2.2.3 - Approved vs Proposed Ground Floor Elevation - Vine Lane (West)

2.2.4 - Approved vs Proposed Ground Floor Elevation - High Holborn (South)

3.1.1 - Approved vs Proposed Servicing Strategy Summary

5.1.1 - Museum Street Elevation (East) - Approved vs Proposed

5.4.1 - Inset Terraces Summary

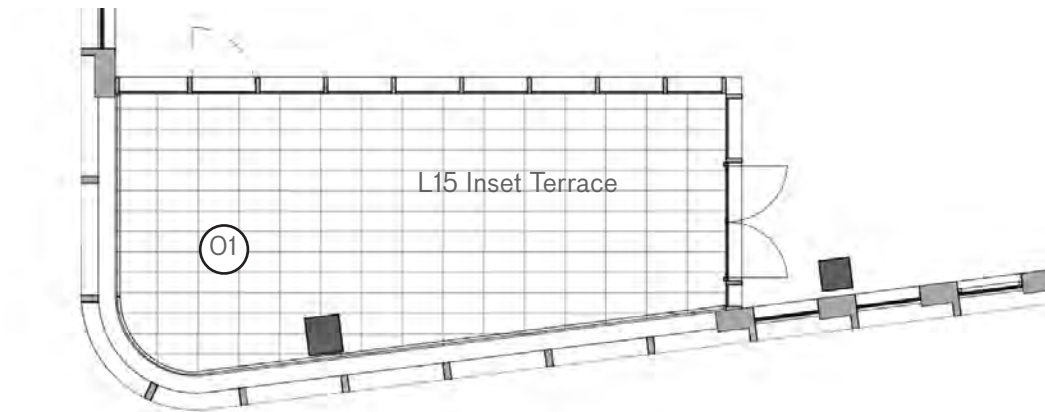
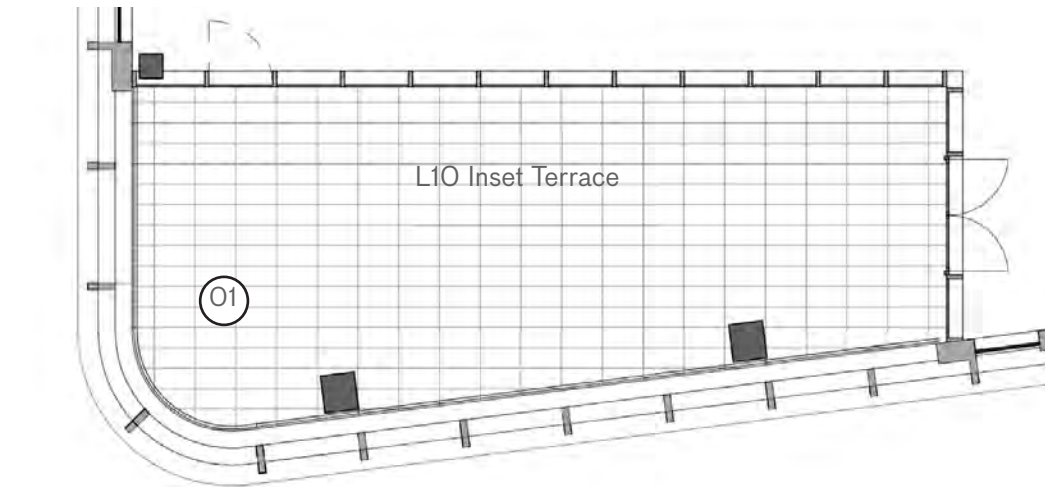
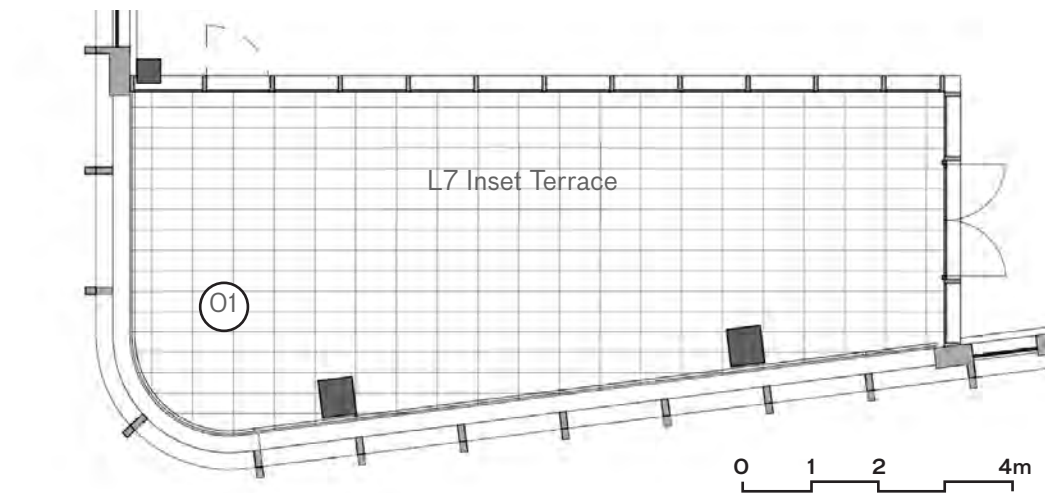
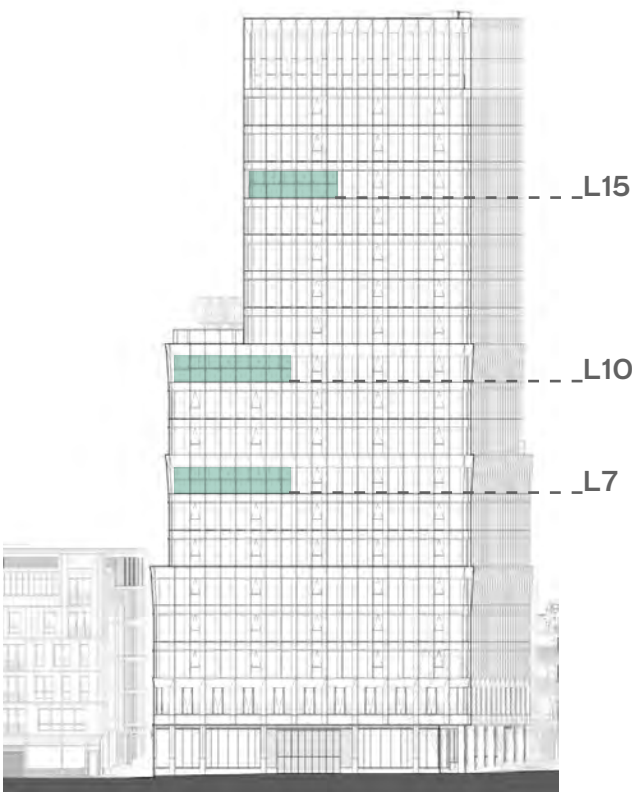
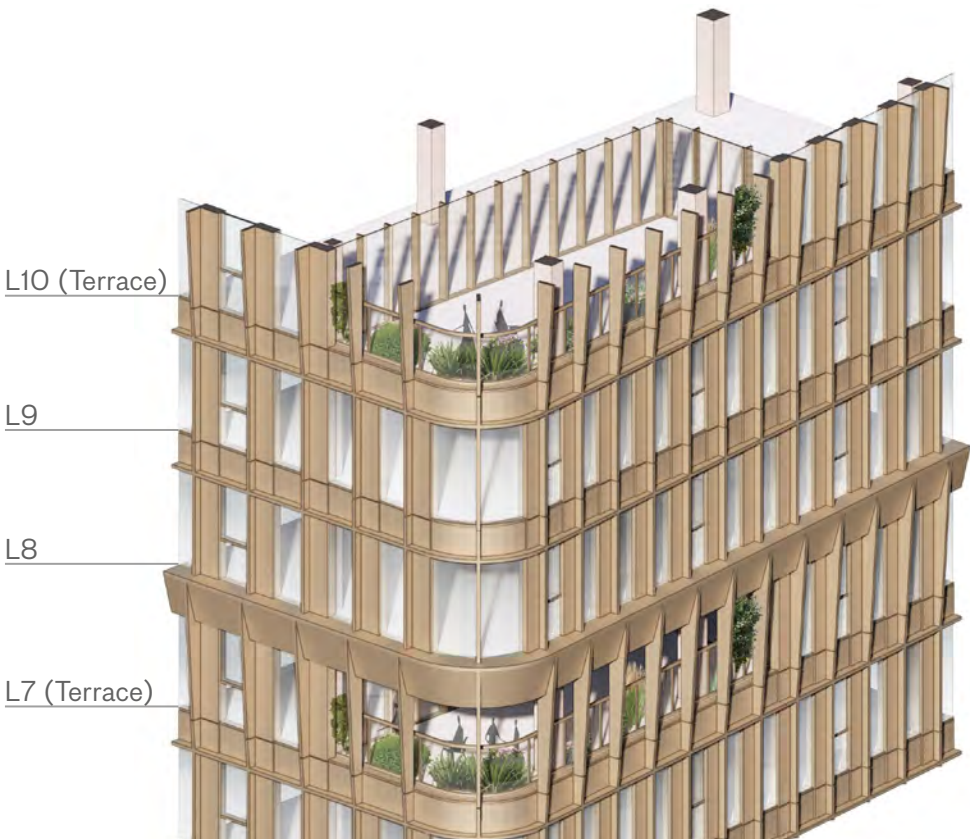
O1. New inset terraces have been introduced on Levels 7, 10, and 15. These provide valuable external amenity space to the associated office floors, offering views across the west end, and add vibrant active character to the external appearance of the building.
